**Telecommunications and exchange  
between information technology  
systems — Requirements for local and  
metropolitan area networks —**

**Part 3:  
Standard for Ethernet**

**AMENDMENT 2: Physical layer and  
management parameters for power over  
Ethernet over 4 pairs**

Figure 30-4—Repeater entity relationship diagram

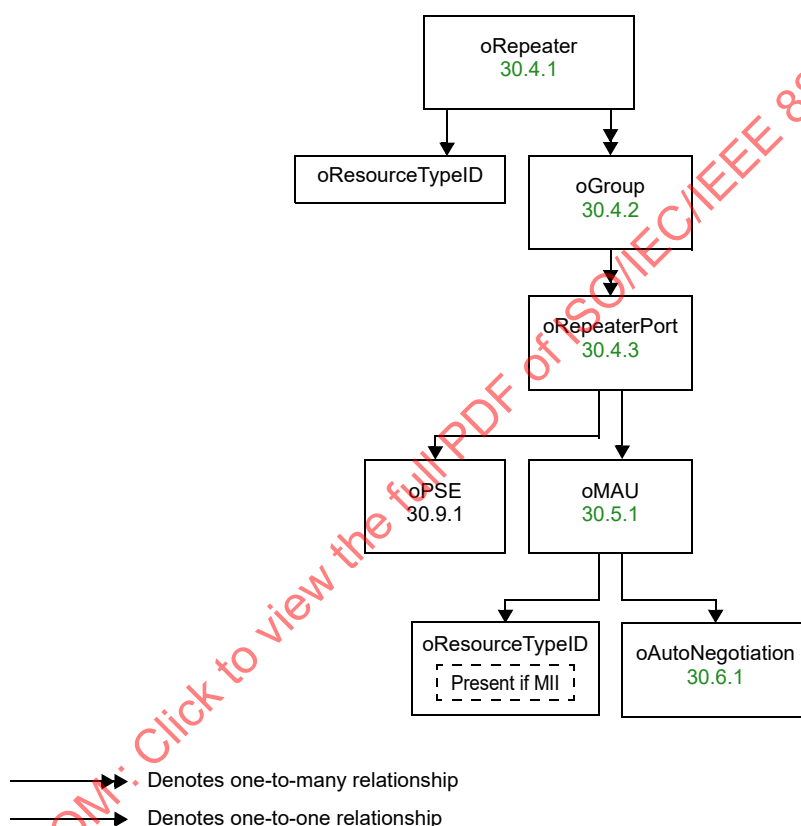
Replace Figure 30-4 as follows (oPD object deleted):

**Figure 33–1—~~DTE Power via MDI~~ PoE powered device relationship to the physical interface circuitry and the IEEE 802.3 CSMA/CD LAN model**

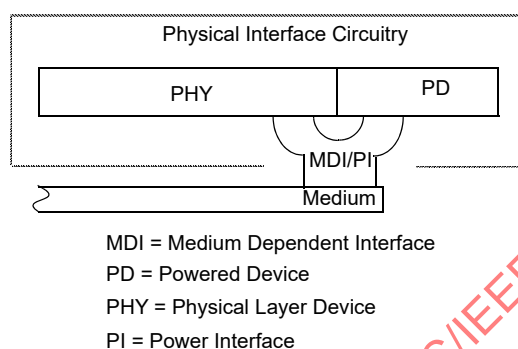
*Change the title and first two paragraphs of 33.1.3 and the titles of Figure 33–1, Figure 33–2, and Figure 33–3 as follows:*

~~DTE Power via MDI~~ Power over Ethernet comprises an optional non-data entity. As a non-data entity, it does not appear in a depiction of the OSI Reference Model. Figure 33–1 depicts the positioning of ~~DTE Power via MDI~~ Power over Ethernet (PoE) in the case of the PD.

Figure 79-3—Power Via MDI TLV format

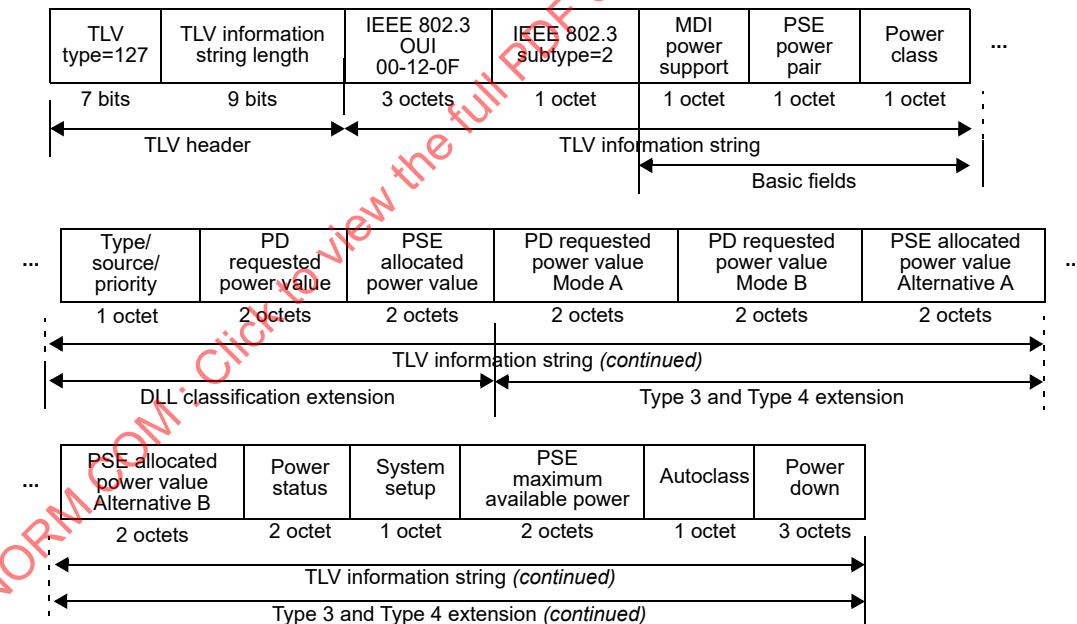
Replace Figure 79-3 with the following:

The Power via MDI TLV shown in Figure 79-3 was originally defined in IEEE Std 802.1AB-2005 Annex G.3. This original TLV supported only the first three fields of Figure 79-3, labeled basic fields, enabling discovery and advertisement of Power via MDI capabilities. The Power via MDI TLV was revised by IEEE Std 802.3at-2009 to add a further three fields, labeled DLL classification extension, to provide Data Link Layer (DLL) classification capabilities. The Power via MDI TLV was revised again by IEEE Std 802.3bt-2018 to add a further nine fields, labeled Type 3 and Type 4 extension, to support additional capabilities offered by Type 3 and Type 4 PSEs and PDs.

Power entities may continue to use the Power Via MDI TLV basic fields shown in Figure 79-3 prior to supplying/drawing power to/from the Power Interface (PI), as defined in 1.4.406. The DLL classification extension fields and Type 3 and Type 4 extension fields shown in Figure 79-3 shall not be sent by the PSE unless it is supplying power to a PI encompassed within an MDI and by the PD unless it is drawing power from the PI.

If a Type 1 or Type 2 power entity implements Data Link Layer classification, it shall support the Power Via MDI TLV DLL classification extension fields shown in Figure 79-3 after the PI has been powered. If a Type 3 or Type 4 power entity implements Data Link Layer classification, it shall support both the DLL classification extension fields and Type 3 and Type 4 extension fields shown in Figure 79-3 after the PI has been powered. Type 1 and Type 2 devices shall not include the Type 3 and Type 4 extension fields in the transmitted Power via MDI TLV.
